<b>Subject:</b>  CLUNK NOISE FROM DRIVE SHAFT	<b>Bulletin No:</b> 03-002/10
	<b>Last Issued:</b> 07/07/2010

## BULLETIN NOTE

- This bulletin supersedes the previous bulletin 03-002/10 issued on 3/8/10 and 6/30/10. The WARRANTY INFORMATION has been revised.
- Changes are noted below in Red beside the change bar.

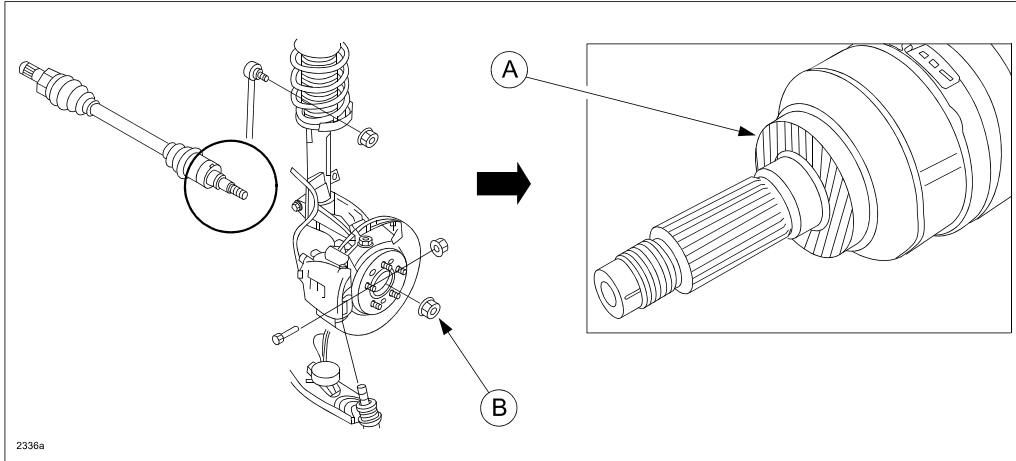
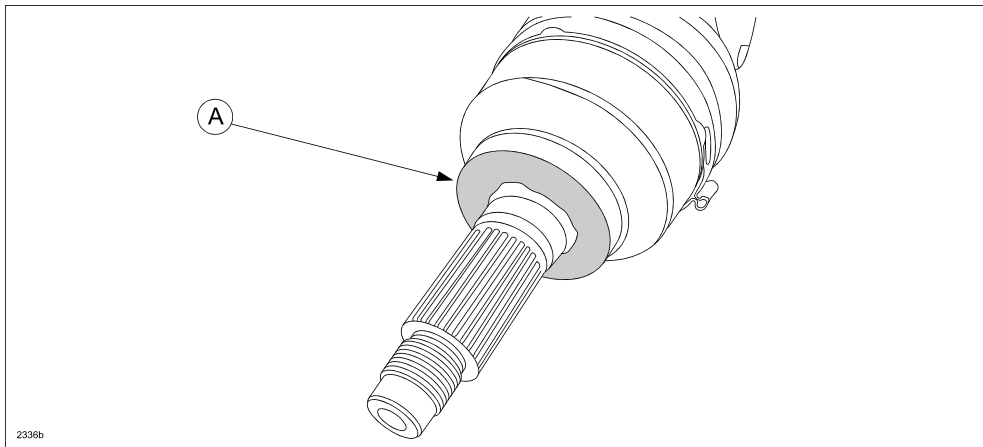
Some vehicles may exhibit a clunk noise from the front drive shaft or the rear drive shaft when moving forward/backward from a stop. This is caused by a stick-slip noise due to excessive force created between the drive shaft and the wheel bearing. Grease is now applied between the drive shaft and the wheel bearing to correct this.

3. Clean the drive shaft and the wheel bearing mating surface (A).

**NOTE:** Replace the nut (B) with a new one.

4. Apply molybdenum grease onto the drive shaft and wheel bearing mating surface (A).

**NOTE:** Be careful not to get grease on the brake disc/caliper.
